Additions and Renovations
Platt Technical High School
Milford, CT

ADDENDUM NO. 3

August 2, 2019

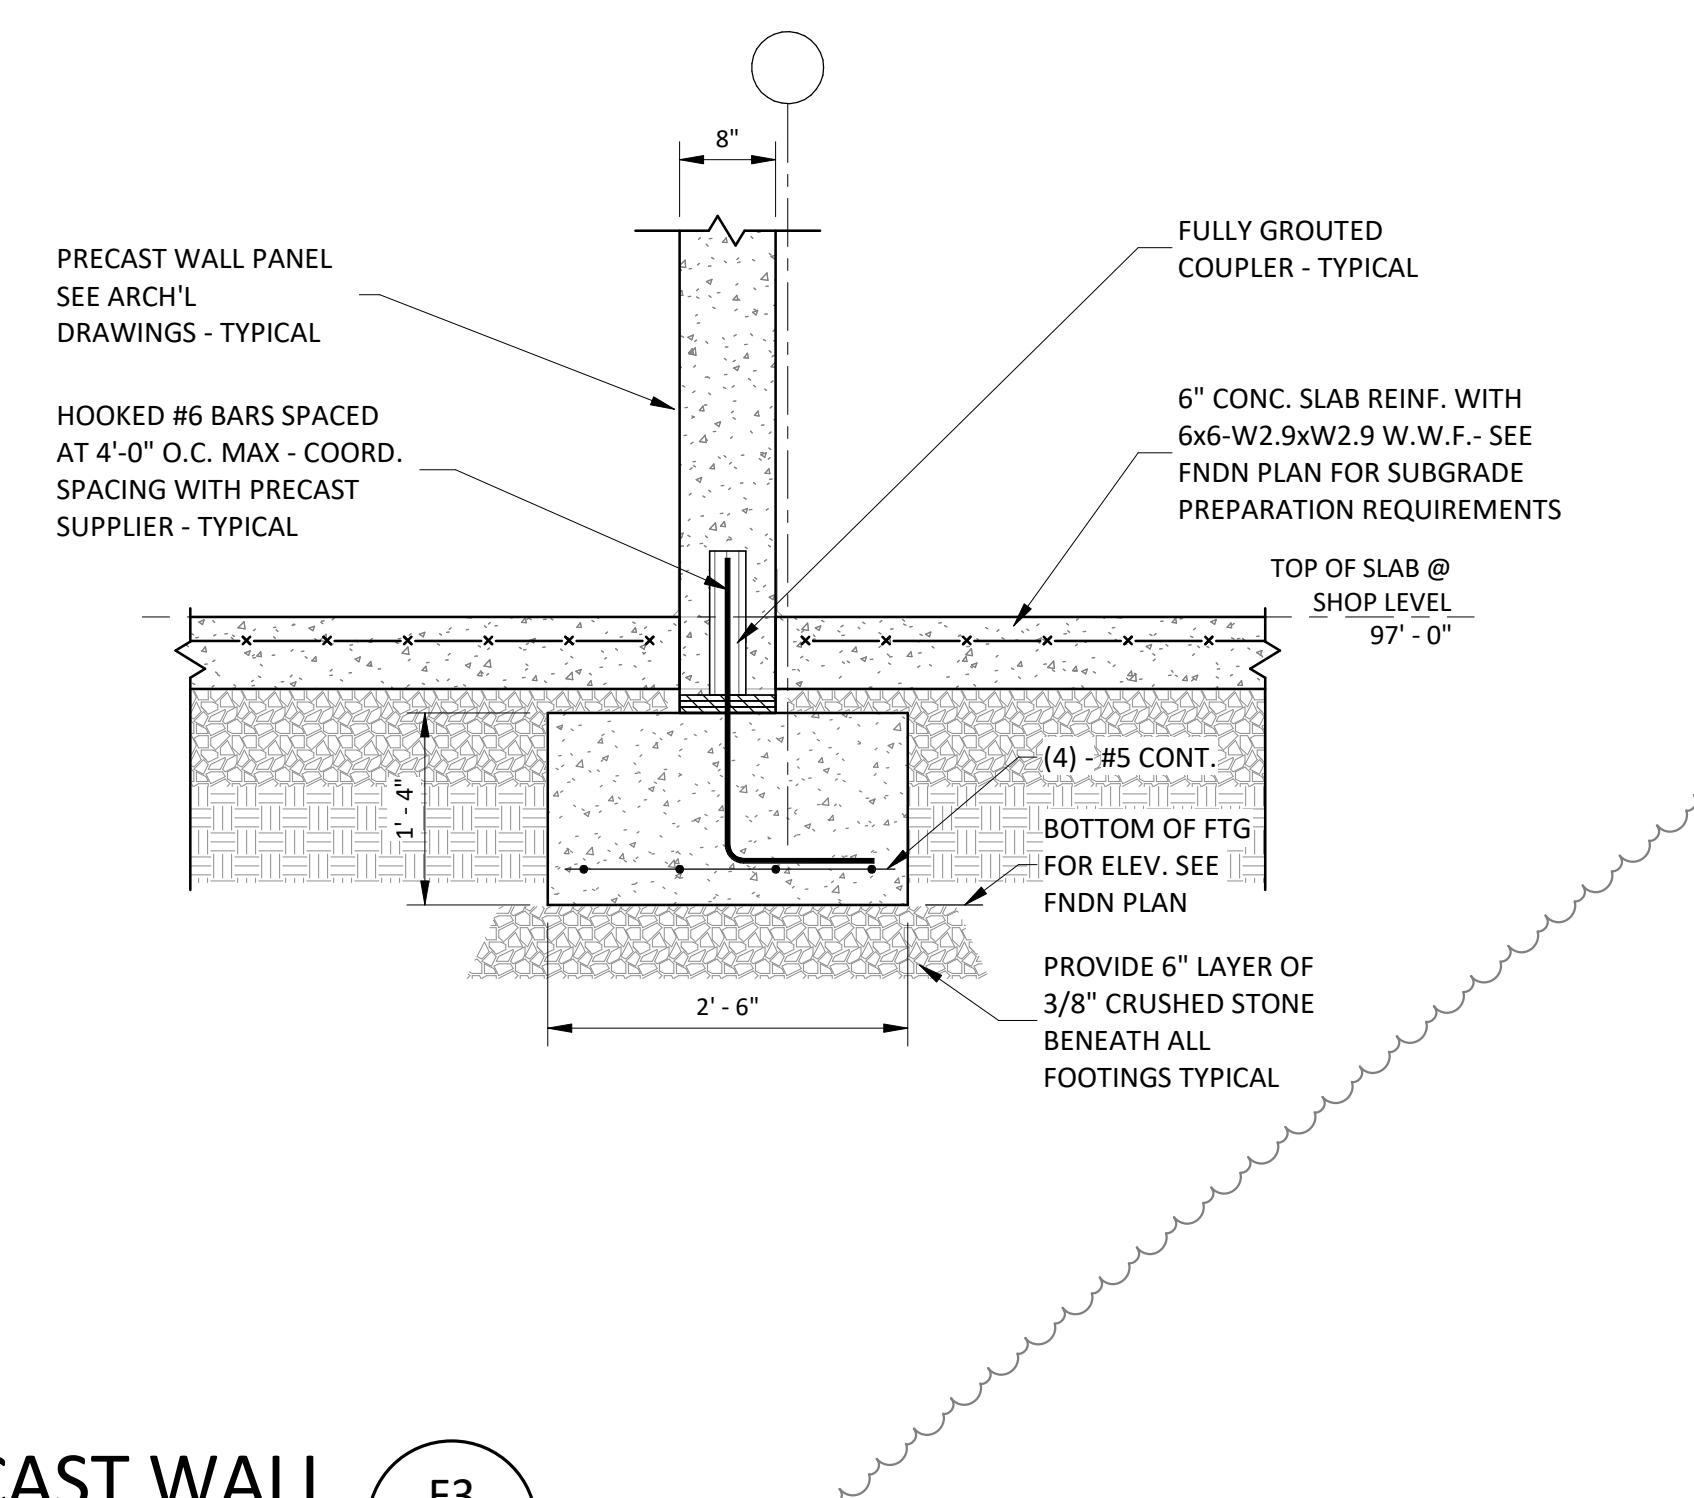
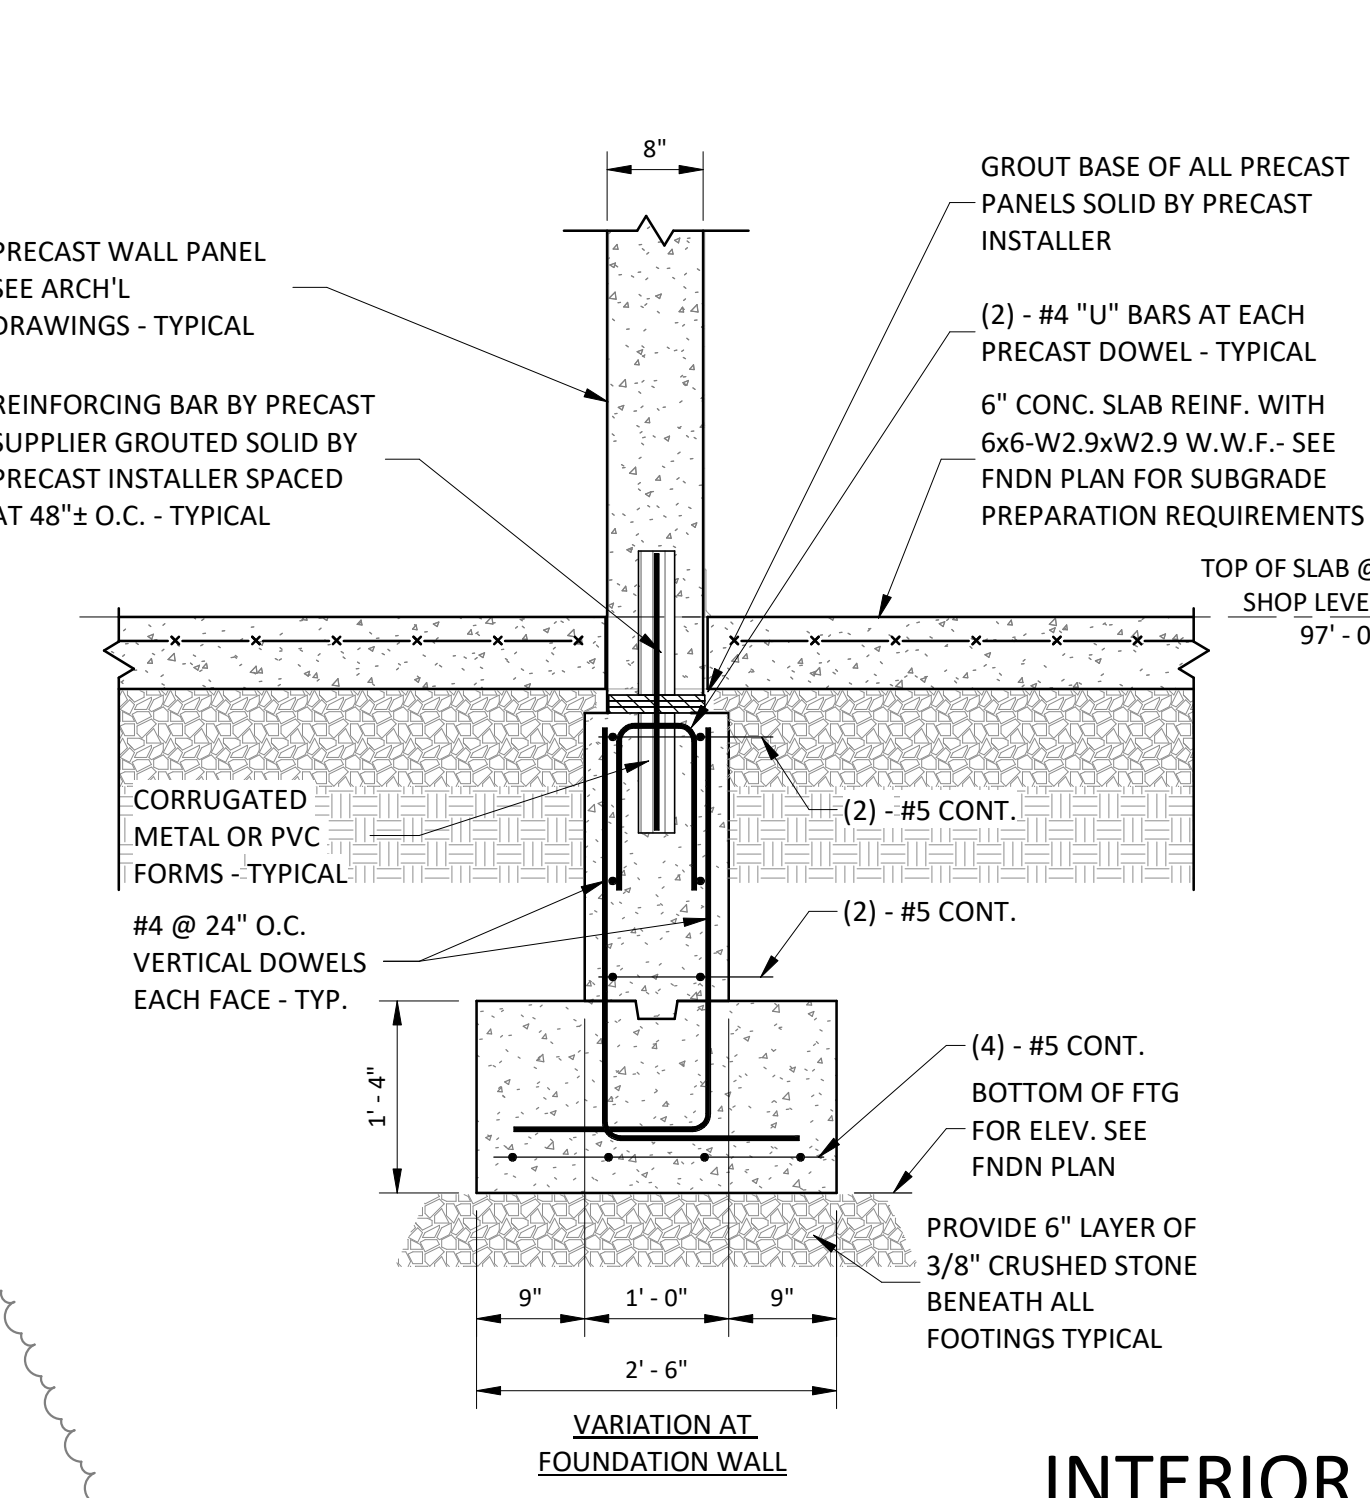
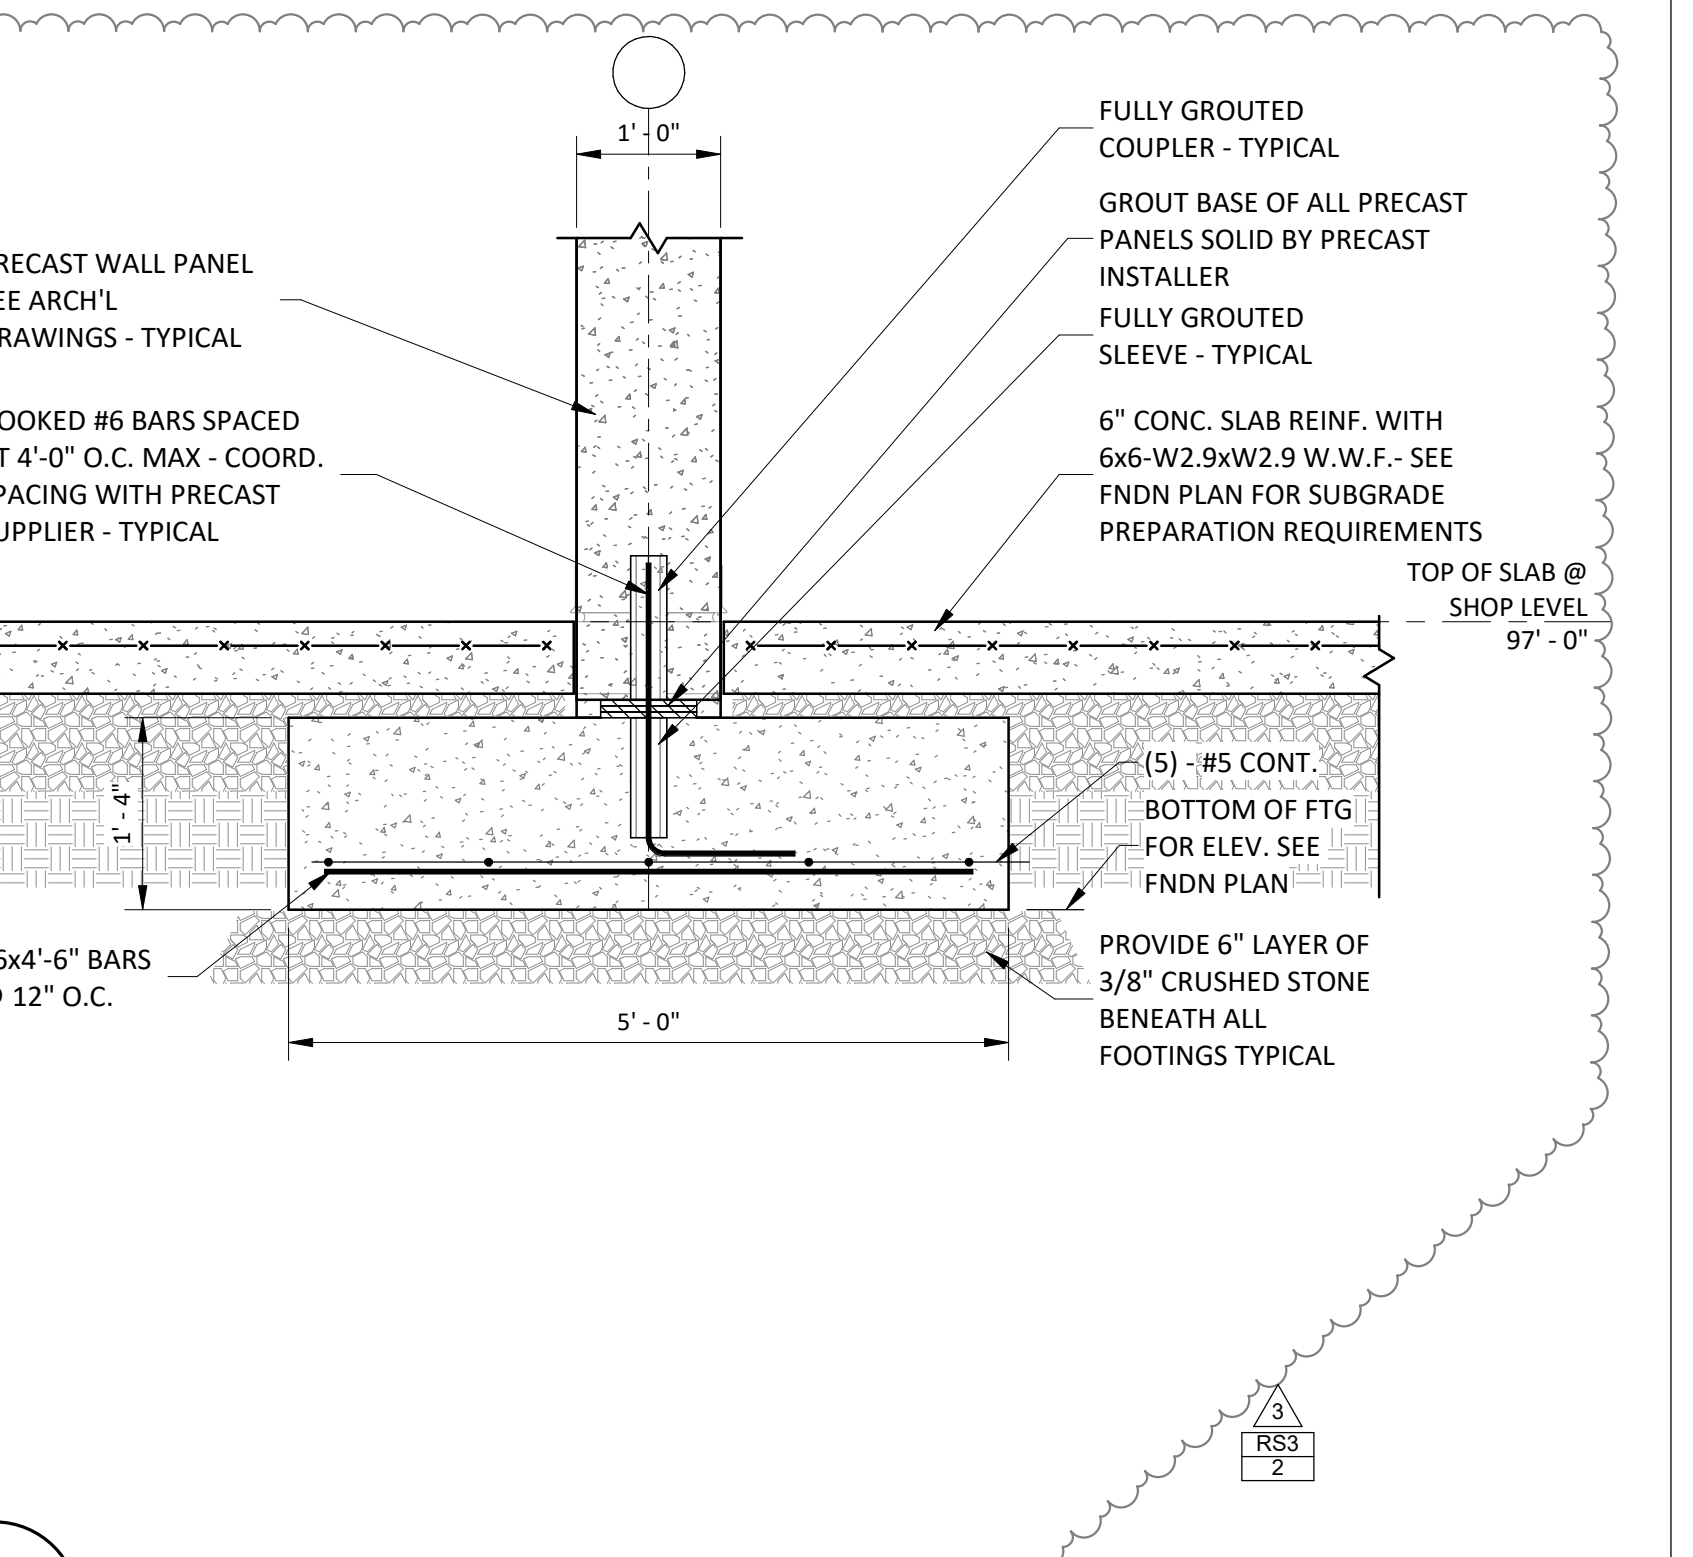
- ADD 3-076 DRAWING S2-4-1 – PRECAST BEAM & TEE SCHEDULE**
Revise Pre-cast Beam Schedule per Sketch RS3-005.
- ADD 3-077 DRAWING S3-2-2 – FOUNDATION PLAN DETAILS**
Added sections F1, F2, F3 for clarification per Revision RS3-2.

- ADD 3-078 DRAWING S3-2-2 – FOUNDATION PLAN DETAILS**
Added plan detail P3 per Revision RS3-001.
